Access Compliance Report

Public Rights-of-Way

(Curb Ramps)

Intersection ID: 30482	Main Street: CREEK_TURN_DR	Cross Street: KRISLYN_WOODS_PL	Location: SE
ADA ID: 21B2FF596B34	Ramp Type: PerpDiag	Initial Pass/Fail: Fail	Overall Compliance: No
Severity Score: 35			
Codes/Mitigation Info/Possible Solution		Field Measurements/Component Compliance

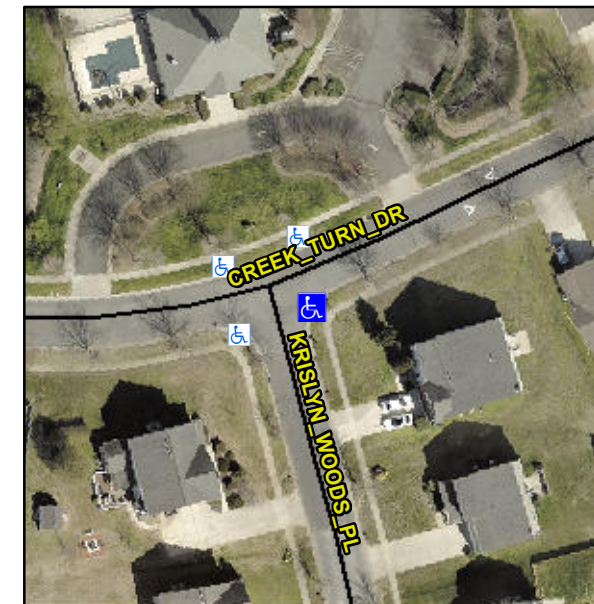
Not Found, R304.5.1

Compliance	Description	Data	Compliance	Description	Data
N/A	Ramp Length (in)	83.0	Yes	Ramp Slope (%)	5.2
No	Ramp Width (in)	31.0	Yes	Ramp XSlope (%)	1.6
N/A	Flare Type LT	N/A	N/A	Flare Type RT	N/A
N/A	Flare Slope LT (%)	N/A	N/A	Flare Slope RT (%)	N/A
N/A	Flare Traversable LT?	N/A	N/A	Flare Traversable RT?	N/A
N/A	Landing Length (in)	N/A	N/A	DWS Provided?	N/A
N/A	Landing Width (in)	N/A	N/A	DWS Contrast?	N/A
N/A	Landing Slope (%)	N/A	N/A	DWS Length (in)	N/A
N/A	Landing X Slope (%)	N/A	N/A	DWS Full Width?	N/A
N/A	Landing Curb? (Y/N)	N/A	N/A	DWS Offset (in)	N/A
N/A	Shared Landing?	N/A			
N/A	Gutter Ponding?	N/A	N/A	Gutter Slope (%)	N/A
N/A	Gutter Lip Ht (in)	N/A	N/A	Gutter X Slope (%)	N/A
N/A	Painted X Walk1?	No	N/A	Painted X Walk2?	No
	X Walk 1 Direction	To N		X Walk 2 Direction	To W
N/A	X Walk 1 Width (in)	N/A	N/A	X Walk 2 Width (in)	N/A
	X Walk 1 Slope (%)	0.9		X Walk 2 Slope (%)	0.4
	X Walk 1 X Slope (%)	0.7		X Walk 2 X Slope (%)	3.3

Remove & Replace Curb Ramp With Two New Directional Ramps or Equivalent.
